MFN 08-303

**Subject: Response to Portion of NRC Request for Additional
Information Letter No. 100 Related to ESBWR Design
Certification Application - Containment Systems -
RAI Number 6.2-160**

**Response to Portion of NRC Request for
Additional Information Letter No. 100
Related to ESBWR Design Certification Application**

RAI Number 6.2-160

Figure 2.15.1-1. Containment System

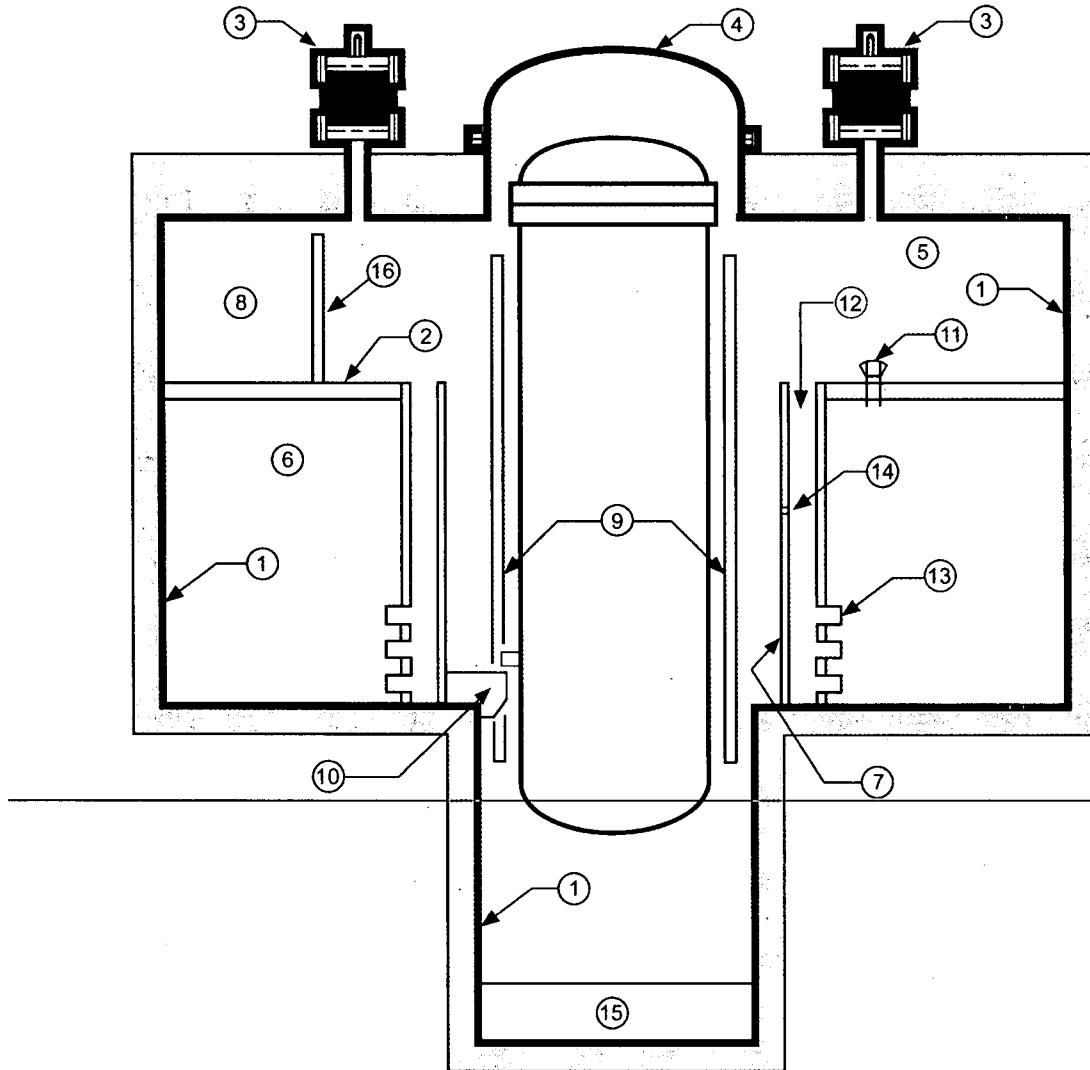
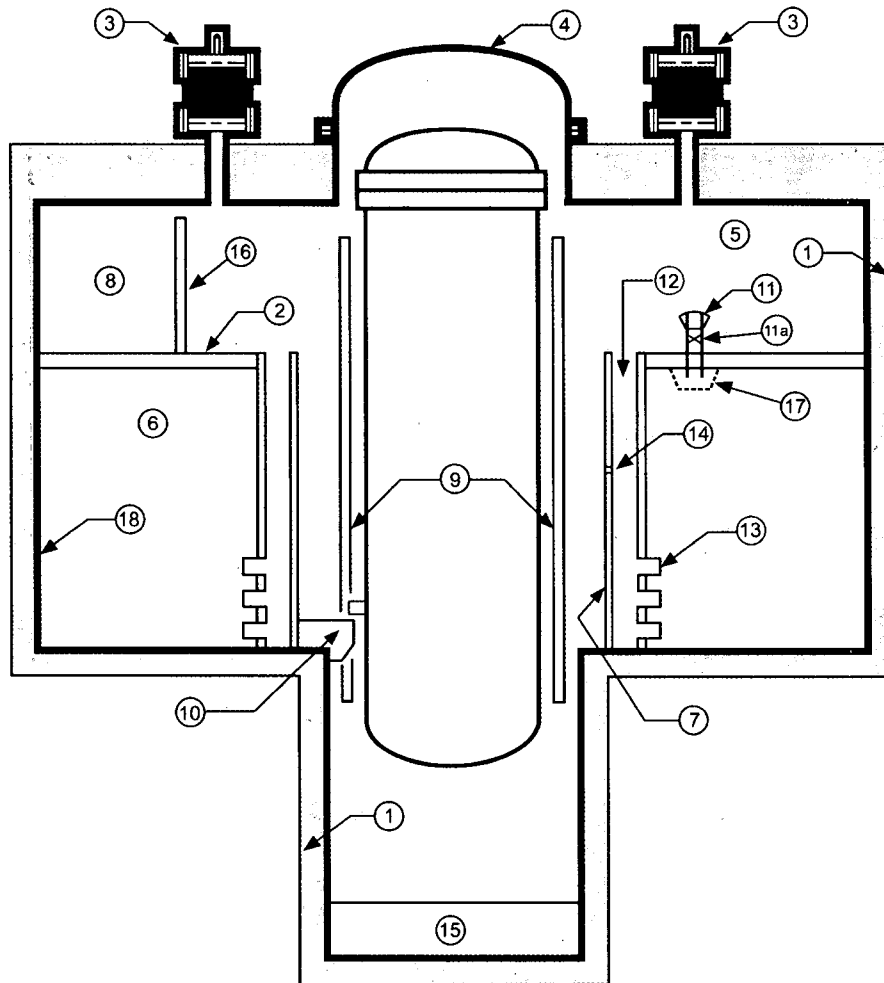
- A. If the PICSM code was used, what liquid and froth impacts were predicted to occur on the vacuum breaker (VB) valves? If impact loads are predicted, then what design features are included providing structural shielding of VB valves from pool swell loads?*
- B. If liquid and froth impacts are not predicted, provide a discussion of the minimum height between the pool surface and the VB to ensure that structural protection is not necessary.*
- C. Provide an ITAAC to verify the minimum height between the pool surface and the VB.*
- D. If the PICSM computer code was not used, how were potential challenges to the VBs and horizontal diaphragm evaluated?*

- C. DCD Tier 1, Figure 2.15.1-1 will be revised to require the diaphragm floor slab to be greater than 9600 mm above the wetwell floor. This physical dimension is the combination of the maximum pool depth (5500 mm) and the maximum pool swell (4100 mm).

1. Reinforced Concrete Containment Vessel (RCCV)
2. Diaphragm Floor Slab, Distance from bottom of slab to the Wetwell Floor > 9600mm
3. (6) Passive Containment Cooling System (PCCS)
4. Drywell Head
5. Drywell
6. Wetwell
7. Vent Wall
8. (3) GDCS Pools
9. Reactor Shield Wall
10. (8) RPV Support Brackets
11. (3) Vacuum Breakers, $\geq 0.6\text{m}^2$ (6.46 ft^2) Total
- 11a. (3) Vacuum Breaker Isolation Valves, $\geq 0.6\text{m}^2$ (6.46 ft^2) Total
12. (12) Vertical Vents, $\geq 13.6\text{m}^2$ (146 ft^2) Total
13. (36) Horizontal Vents, $\geq 0.7\text{m}$ (2.30 ft) I.D.
14. (12) Spillover Holes, 200mm (8 inch) Nominal Diameter, Elevation 12370 mm
15. BiMAC
16. GDCS Pool Wall (Typical)
17. Protective Shield/Debris Screen
18. Suppression Pool Stainless Steel Liner
